July 9, 2018

Product Improvement Notice - Solera Smart Arm potting and software

Fig.1

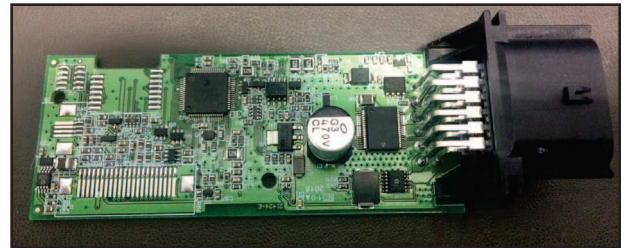
A through-hole notch (Fig. 1) has been added to the Printed Circuit Board (PCB) to improve potting flow and ensure complete potting to prevent moisture intrusion in to the circuit board and controller.

Along with the through-hole notch (**Fig. 1**) LCI has:

- Implemented a new vibratory table to the potting process to improve flow and fill around PCB/electronic components.
- Added a dynamic mixing process to potting to improve mixture.
- Incorporated a heat gun to the process to significantly remove bubbles in cured potting.
- Reduced PCB size to allow potting to fully encapsulate.
- Changed from high temp to room temp cure to improve flow and fill of potting.

Fig.2

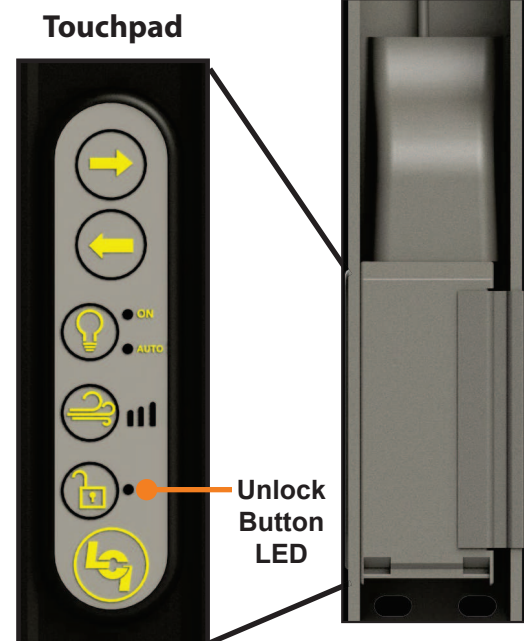
If a Level 1 fault is detected, the touchpad unlock LED (**Fig. 2**) will blink continuously (same as a low voltage fault) to alert the user that moisture is detected. While the interior extend switch and light will be locked out, the exterior touchpad will remain functional (unless a Level 2 fault is also found). On equipped units, OneControl functionality will not be actively locked out, however water in the connector can prevent operation. If a Level 1 Fault has not been detected in the previous 100 seconds, pressing any touchpad button will clear the fault, as will a power cycle on the Smart Arm controller.

Face of the touchpad will now have a protective film overlay that must not be removed.

Fig.3

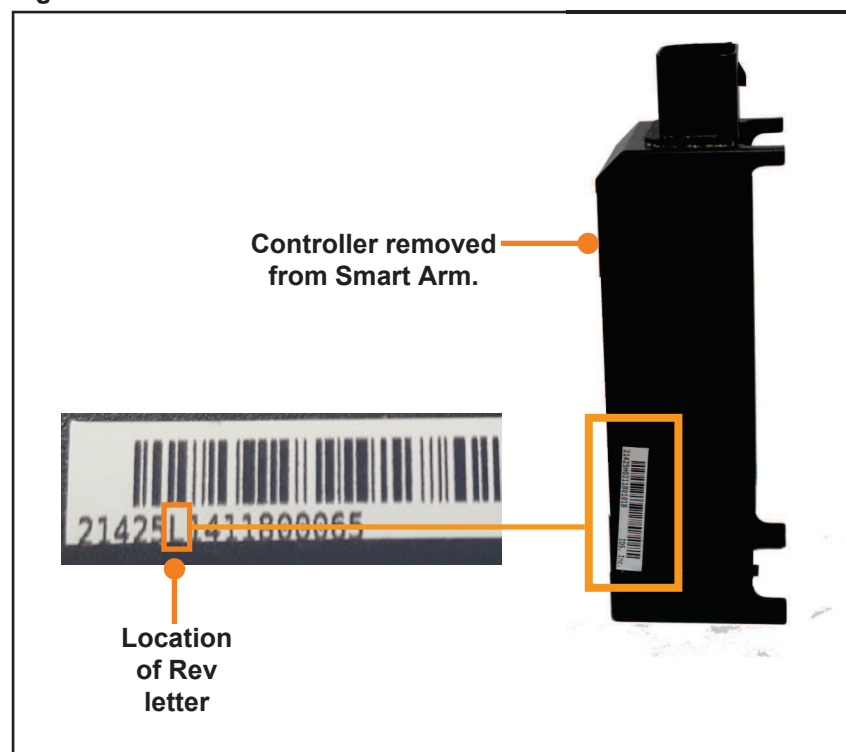
The changes are being made on a running basis, starting immediately. There is no change in installation and no price change. The new Smart Arms with the improved features will have the REV letter L added to the serial number (Fig. 3), replacing the current version.
